Access Compliance Report Public Rights-of-Way (Curb Ramps)

Main Street: HICKORY_BRANCH_RD Cross Street: TIFFANY_PL Location: NW

ADA ID: RPRK220103143521 Ramp Type: Type 4 - Parallel Initial Pass/Fail: Fail Overall Compliance: No Severity Score: 2

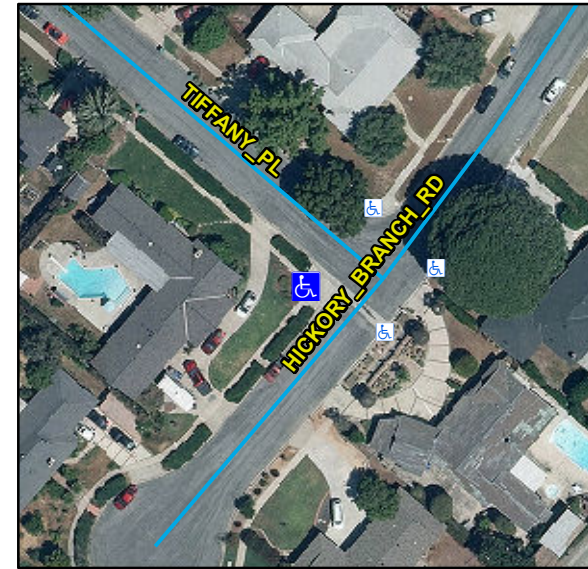
R204.3, R304.5.3, STD 1115

Compliance	Description	Data	Compliance	Description	Data
N/A	Ramp Length LT (in)	130	N/A	Ramp Length RT (in)	126
Yes	Ramp Width LT (in)	90	Yes	Ramp Width RT (in)	94
Yes	Ramp Run Slope LT (%)	7	Yes	Ramp Run Slope RT (%)	6.3
Yes	Ramp Cross Slope LT (%)	1.9	No	Ramp Cross Slope RT (%)	3.6
N/A	Landing Present	N/A	N/A	DWS Provided	N/A
N/A	Landing Length (in)	N/A	N/A	DWS Contrast	N/A
N/A	Landing Width (in)	N/A	N/A	DWS Length (in)	N/A
N/A	Landing Run Slope (%)	N/A	N/A	DWS Full Width	N/A
N/A	Landing Cross Slope (%)	N/A		DWS Offset Type	N/A
N/A	Landing Movement Obstructed?	N/A	N/A	DWS Offset Left (in)	N/A
	Landing Movement Type	N/A	N/A	DWS Offset Right (in)	N/A
N/A	Landing Shared	N/A			
N/A	Clear Space	Yes			
N/A	Clear Space To Crosswalk (in)	N/A			
N/A	Marked Crosswalk 1	No	N/A	Marked Crosswalk 2	No
	Crossing 1 Direction	SE		Crossing 2 Direction	NE
	Marked Crosswalk 1 Width (in)	N/A		Marked Crosswalk 2 Width (in)	N/A

Remove & Replace Curb Ramp With Two New Directional Ramps or Equivalent.
